From: Singh, Sumeet  
Sent: 11/8/2013 6:43:54 PM  
To: Shori, Sunil (sunil.shori@cpuc.ca.gov)  
Cc: Yura, Jane (/O=PG&E/OU=CORPORATE/CN=RECIPIENTS/CN=JKY1); Redacted  
Redacted Doll, Laura (/O=PG&E/OU=CORPORATE/CN=RECIPIENTS/CN=LRDD)  
Bcc:  
Subject: RE: Line 147 Follow-up Items (Week of October 28, 2013)

**From:** Singh, Sumeet  
**Sent:** Saturday, November 02, 2013 12:33 PM  
**To:** 'sunil.shori@cpuc.ca.gov'  
**Cc:** Yura, Jane; Doll, Laura; [Redacted]  
**Subject:** Line 147 Follow-up Items (Week of October 28, 2013)

**5. Regulator Station B43 ([Redacted]) - Complete**

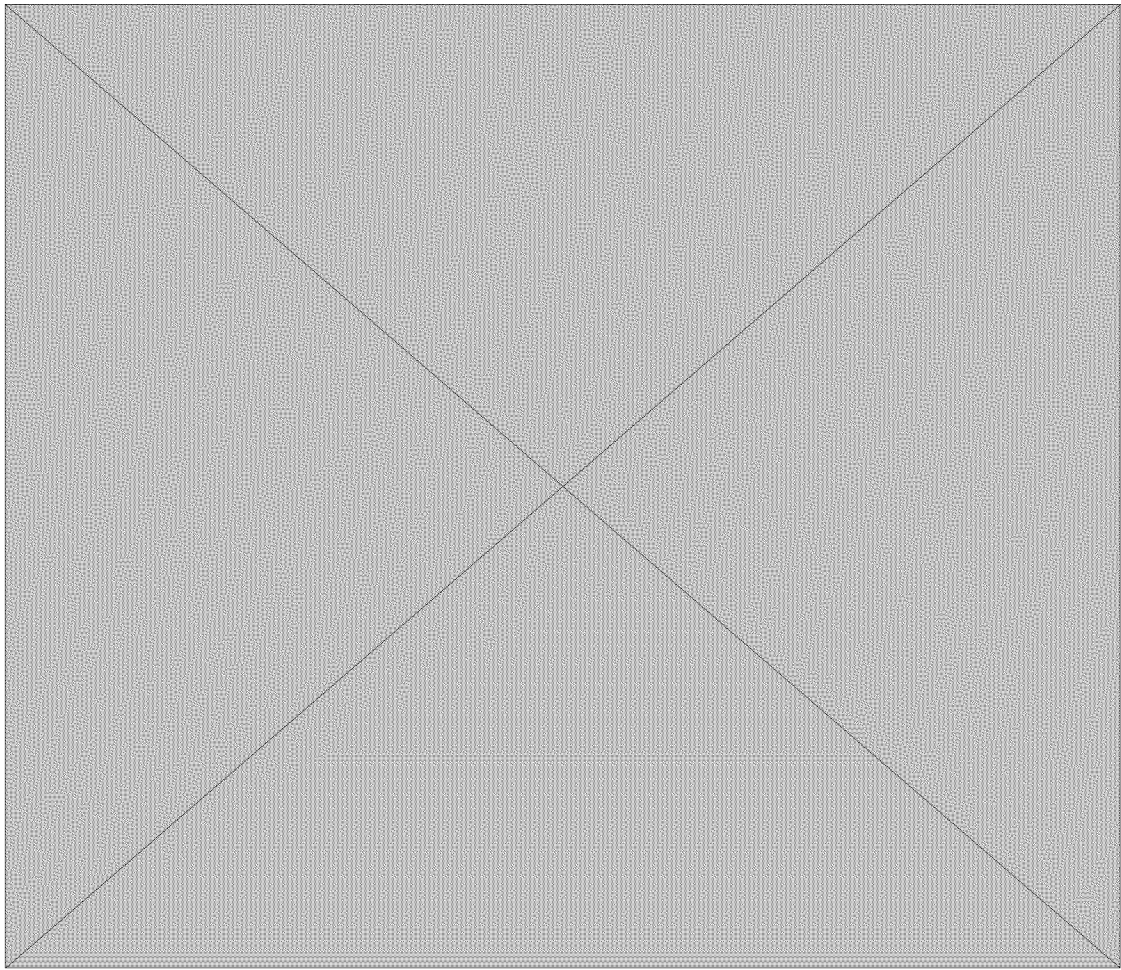
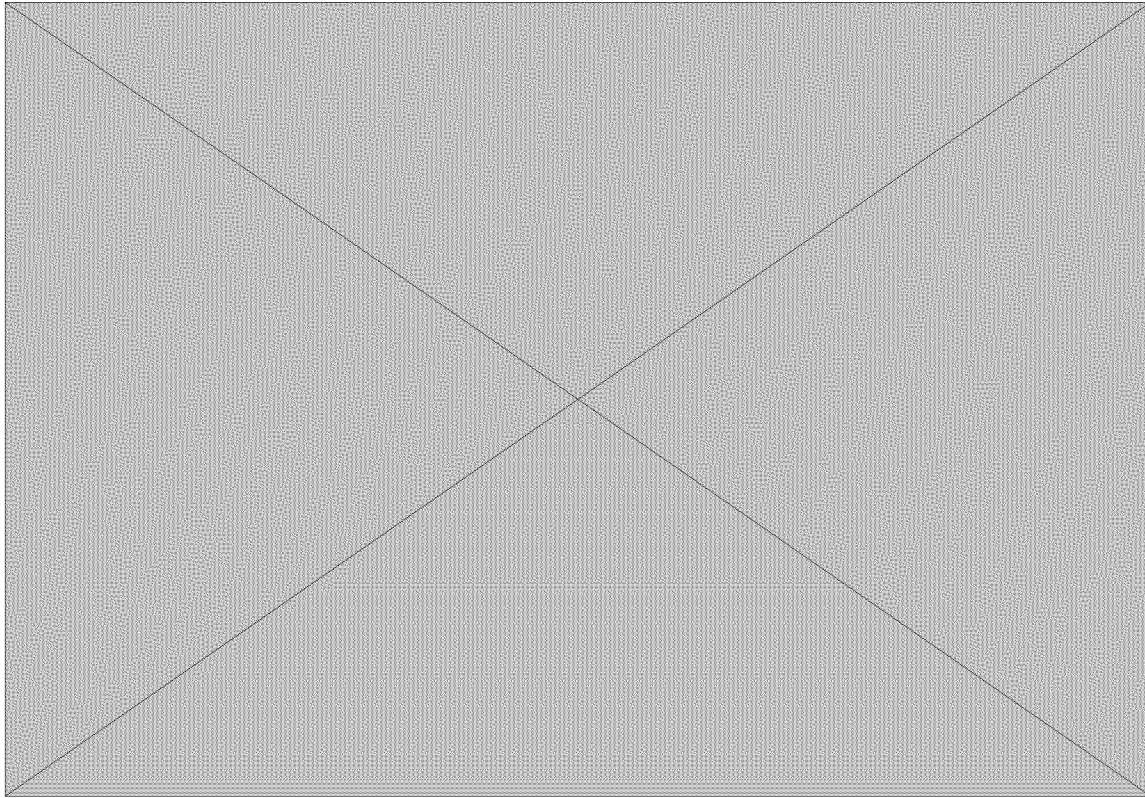
Based on your site visit, you identified an aboveground district regulator station susceptible to potential vandalism as the valves were not locked and there was no fence around the station. Based on a follow-up site visit performed by our field technicians, we installed locks on all valves on 11/1 and a temporary fencing will be installed on 11/4. The installation of permanent fencing will require permitting from various environmental agencies; hence, taking significantly longer to implement which we will continue to pursue. I will provide you with the associated documentation as it becomes available.

Please refer to the attached pictures below.

10/25

11/1
